BOULDER COUNTY BOARD OF ADJUSTMENT
AGENDA ITEM
Wednesday September 4, 2024 4:00 P.M.

Docket VAR-24-0003: Murphy Schmidt Setback Reductions

Request: Request to reduce the front yard setback along Jasper Drive from 35 feet (required) to 5.6 feet (proposed) and the side yard setback from 7 feet (required) to 3 feet (proposed) to permit an existing wellhouse and to reduce the front yard setback from 35 feet to 13.5 feet to construct a residential accessory structure.

Front Setback Variance Application

Figure 1: Map of Lyons Park Estates, Lots 3-4, 12-16, and 19, showing configuration of lots and portions divided off after platting.

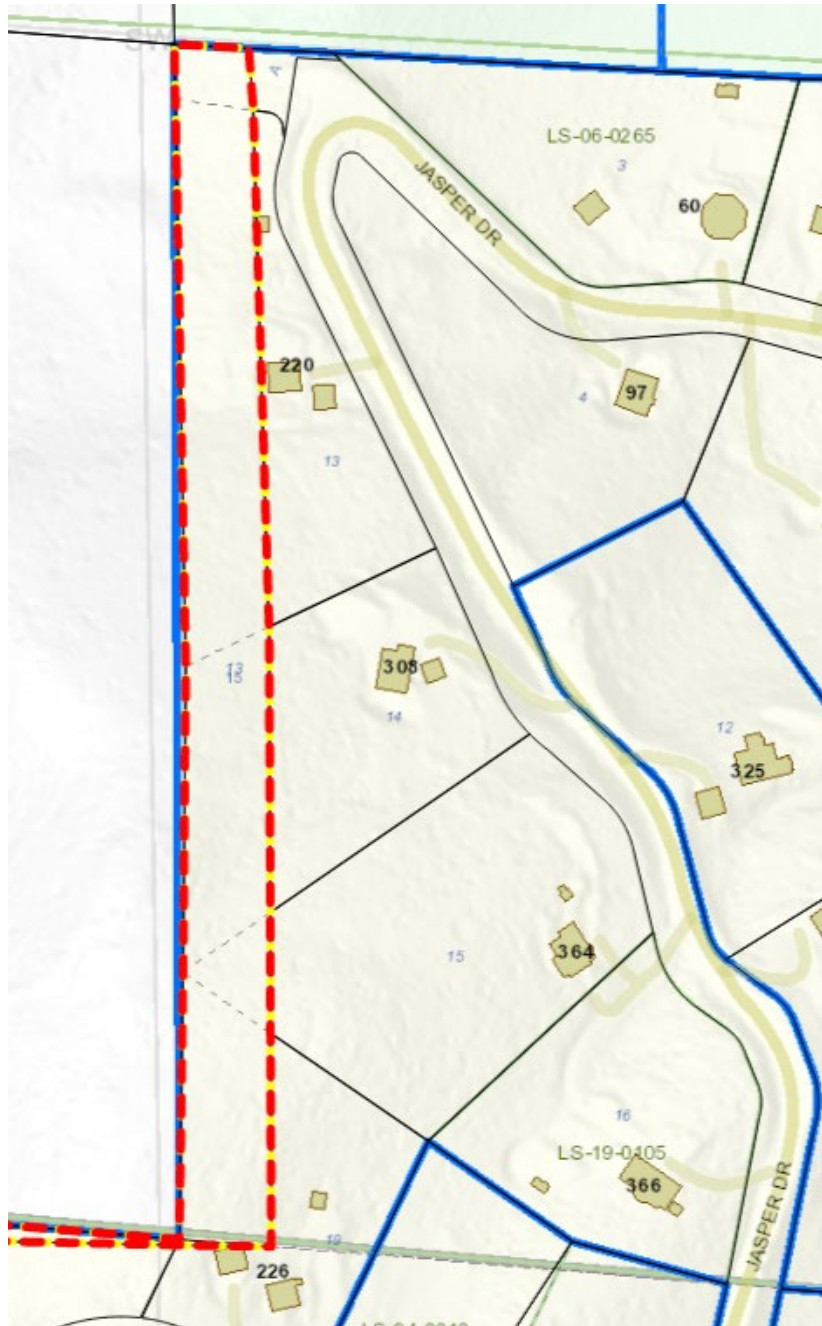
Consequently, shown in Figure 1 below, this resulted in an irregular shape for the subject property that is not present in Lots 14 and 15 and deviation from the approved plat.

Figure 2: 1977 Aerial detail photo, showing existing wellhouse and garage circled in yellow. Note, the aerial imagery does not align with drawn parcel boundaries.

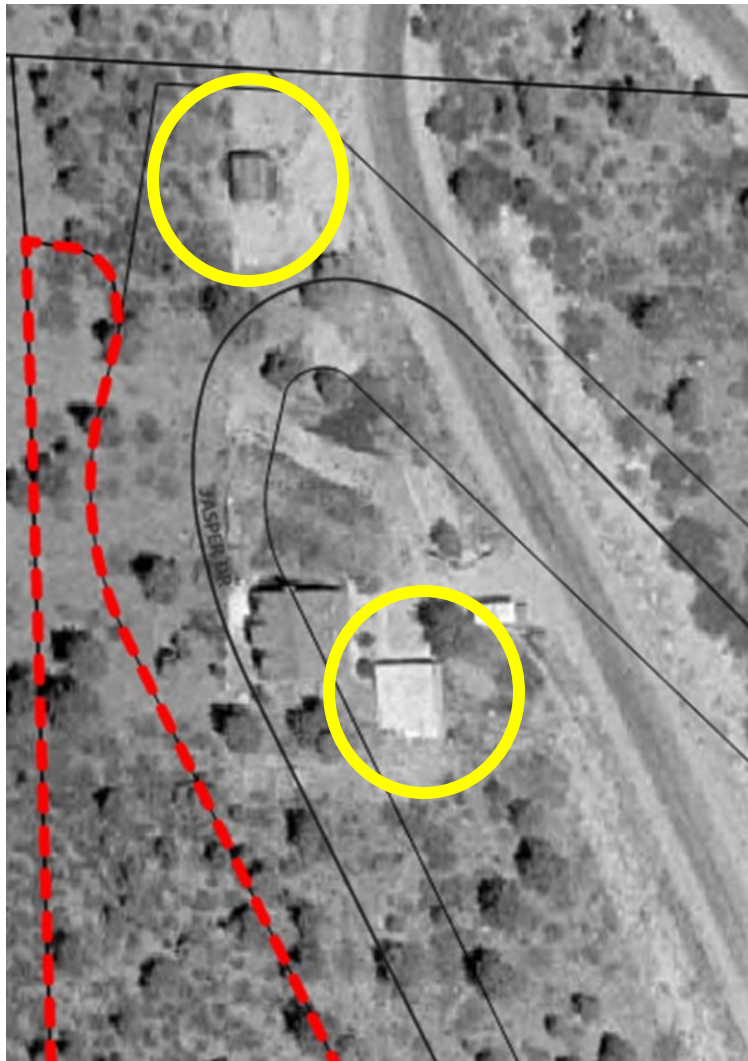
The well house is located in the northern “neck” of the subject property, where the property narrows to approximately 28 feet. Based on staff analysis of building permit records and historic aerial photography, the well house appears to have been constructed between when the residence was constructed in 1969 and in or prior to 1977 when it appears in aerial imagery (see Figure 2 below). The proposed residential accessory structure is located southeast of the residence, sharing approximately the same footprint as the existing detached garage. The applicants refer to the structure as a carport, but as it is enclosed on three sides and therefore does not meet the definition of carport (Article 18-123A). Similar to the well house, the garage was constructed after the residence and in or prior to 1977.

Public Lands & CEs

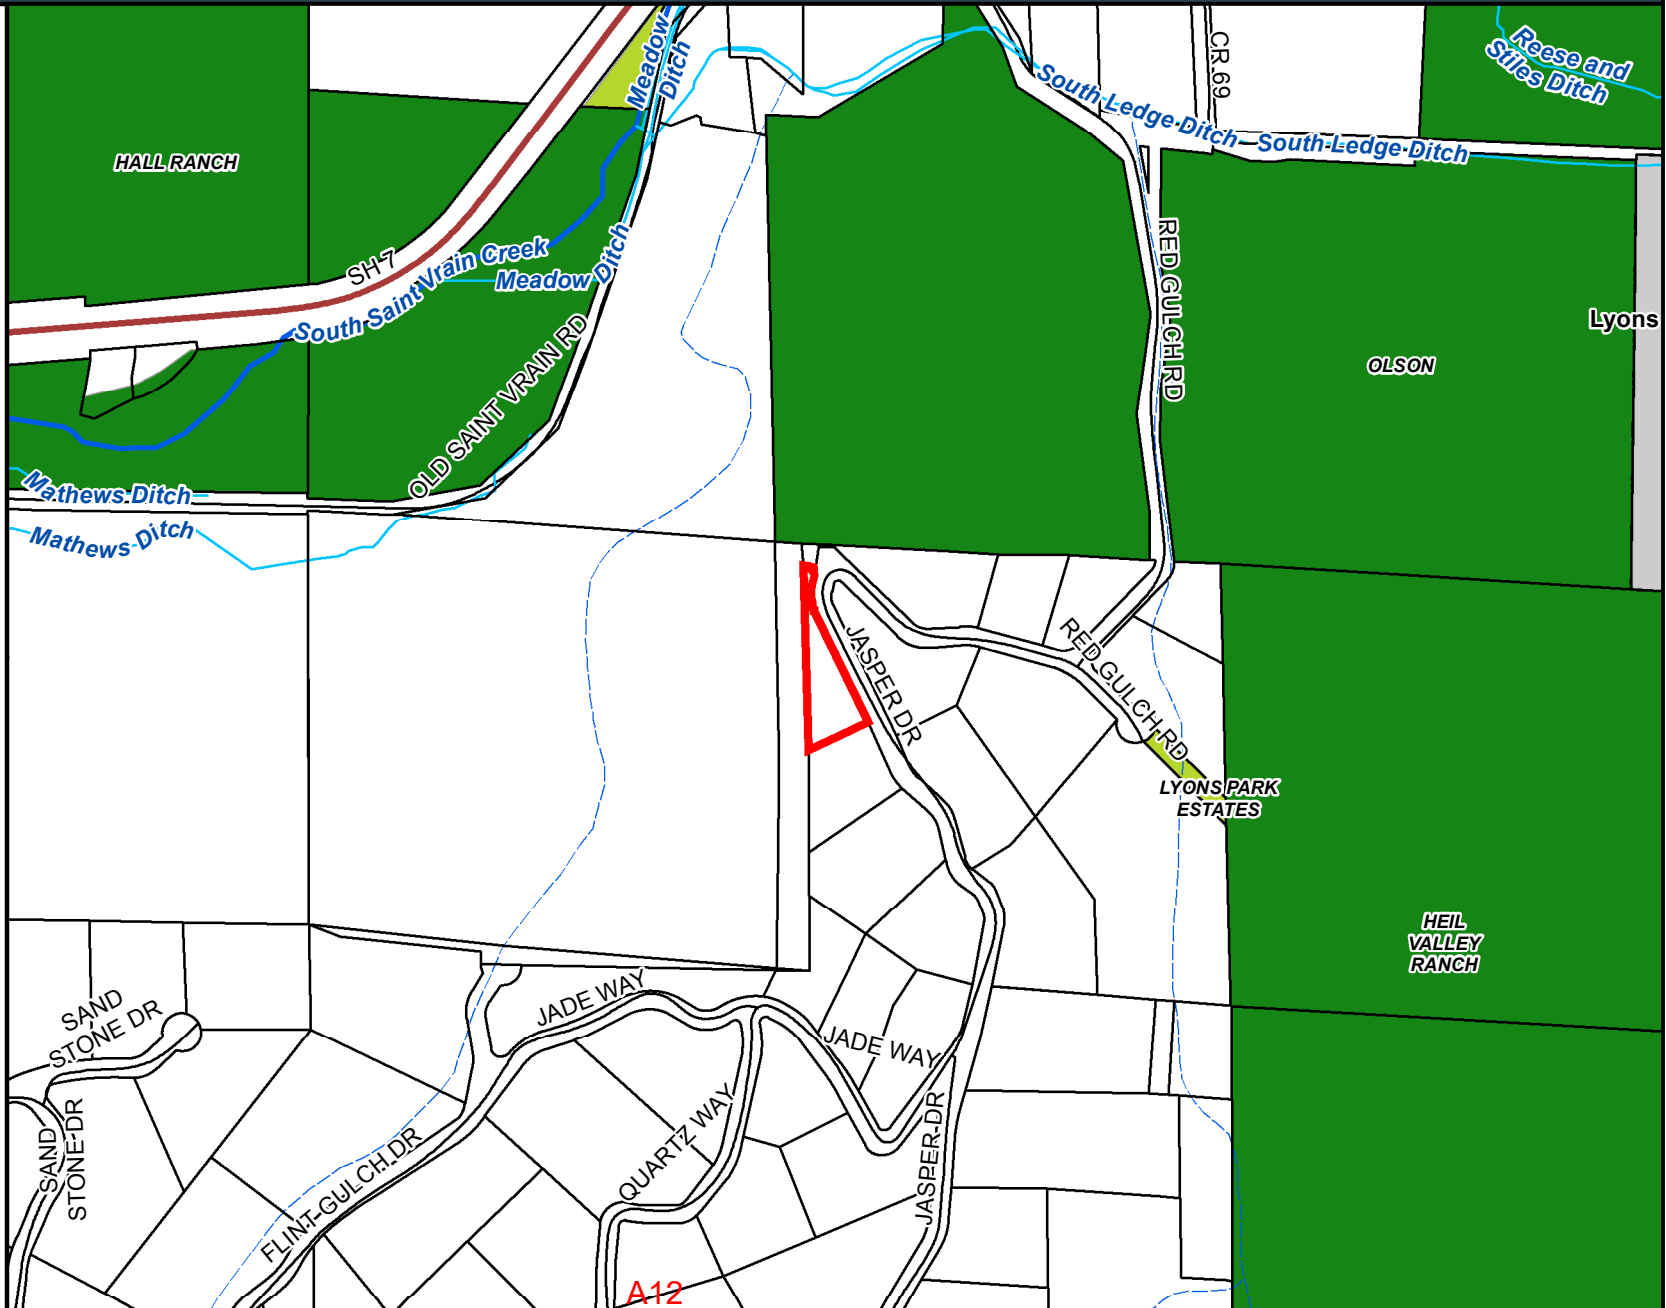
Staff also notes, for the record, that the very small adjacent parcel to the north is county/POS land – right at the apex of the switchback. This does not show on the public lands map in the packet.
